# 802.3dj D2.3

## Comment Resolution

## Electrical Topics

# Introduction

### Reference transmitter does not meet SNDR requirements

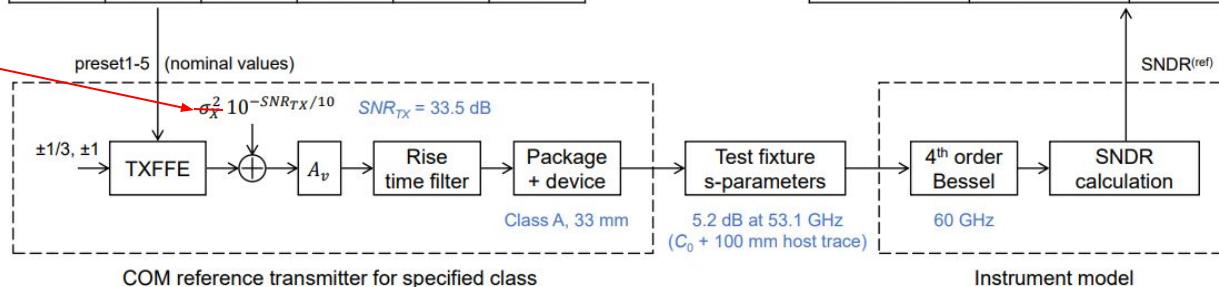
Error in slide

Figure 176D-2—200 Gb/s per lane AUI-C2M link diagram

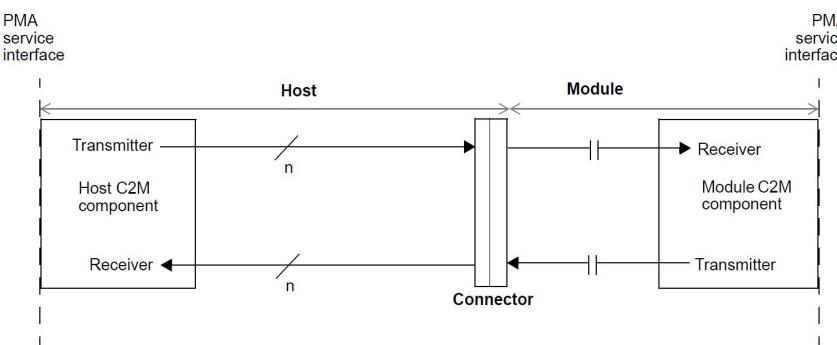
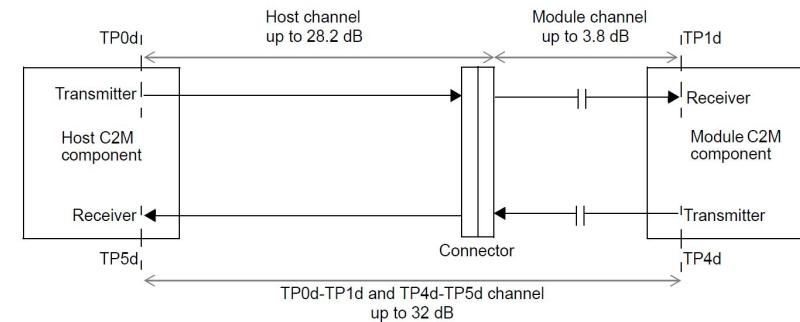
In Figure 176D-2, the delineation between host and module is shown to be the outer edge of the box labeled "connector". However, in Figures 176D-4 and 176D-5, the host and module are shown to extend to the line in the middle of a similar looking "connector" box. Figure 176D-2 should be changed to be consistent with the other figures.

In Figure 176D-2, move the point where the arrows delineating "host" and "module" meet to align with the line in the middle of the box labelled "connector". If there is ambiguity about what this line represents, add a note to the figure indicating that the line corresponds to the "mating point of the MDI connector" similar to what is described in 179B.2.1 and 179B.3.1.

Figures 176D-2 and 176D-6 are intended to show the delineation points between the host and the module.

Up until D2.2 they included one box labeled "connector" which represented the host's receivable, explicitly stated as part of the host channel.

Following resolution of comment #405 against D2.2, in D2.3 the box was split and is now it supposedly represents two mated connectors (host receivable and module plug) although the label still says "connector".

Figure 176D-2 is illustrative, and labeled "Link diagram". As such it is correct.

Reject.

Figure 176D-2 is correct as a link diagram.

The proposed change could be considered an improvement, but it is partial and not essential at this time.

Figure 176D-5—Module compliance points

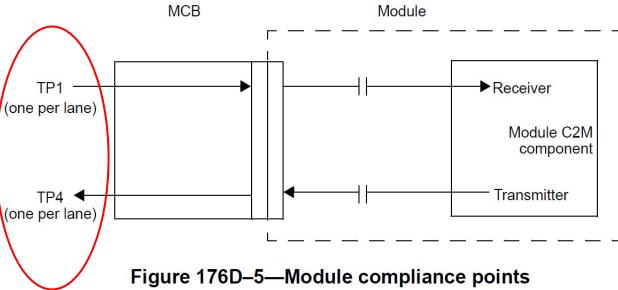
Figures 176D-4 and 176D-5 are intended to show the compliance points, not the host/module connection.

The “split rectangle” in these figures is not labeled “connector” and does not adequately show the connection of the host/module to the test fixture (it is not the focus of these figures).

It can be assumed that the vertical lines indicate the mating points between the receptacle and plug, but it is not stated explicitly (the terms *receptacle* and *plug* are not used anywhere in this annex).

Figure 176D-4—Host compliance points

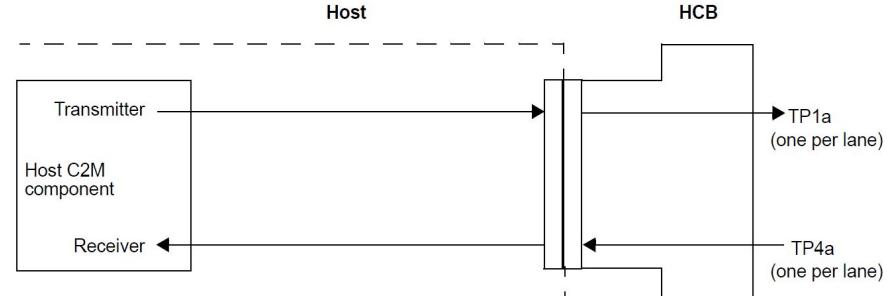
There is no DC blocker on the test setup of the host figure - TX as well as RX paths + no description of the DC block on the host input. The module connected in the host TX and RX path has dc blockers(page 819) allowing the host device to operate at its own voltages, we should add the DC blockers also in the host TX and RX test setup to allow the same conditions.

Add DC blocker between the HCB and the Tp1a and Tp4a + definition in 176D.6.6 host input - as done on 176D.6.4 line 50, on the right of the HCB

In discussion with the commenter he indicated that the main issue is that *host input characteristics do not specify a test setup with AC coupling*, unlike host output (module input and output are specified to be AC coupled within the module).

Figure 120G-9—Example host stressed input test

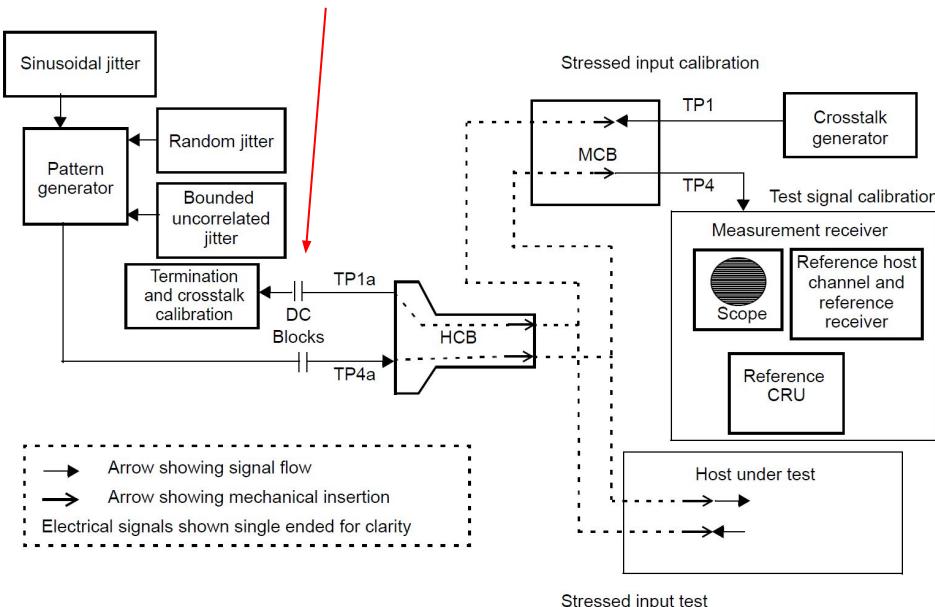
Previous host input test setup diagrams, e.g. Figure 120G-9, included “DC blocks” between the pattern generator and the HCB.

Figure 176D-7a—Host interference tolerance test setup

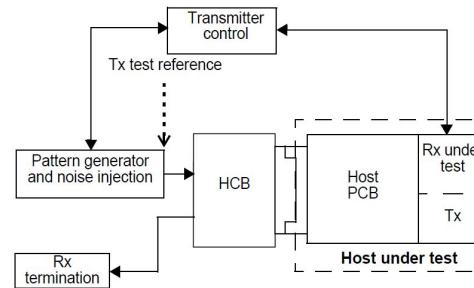
Figure 176D-7a does not.

Add an indication of “DC blocks” between the pattern generator and the HCB, as in Figure 120G-9

Figure 176D-7a—Host interference tolerance test setup

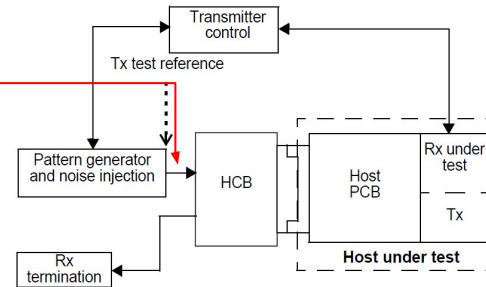
Possible change:
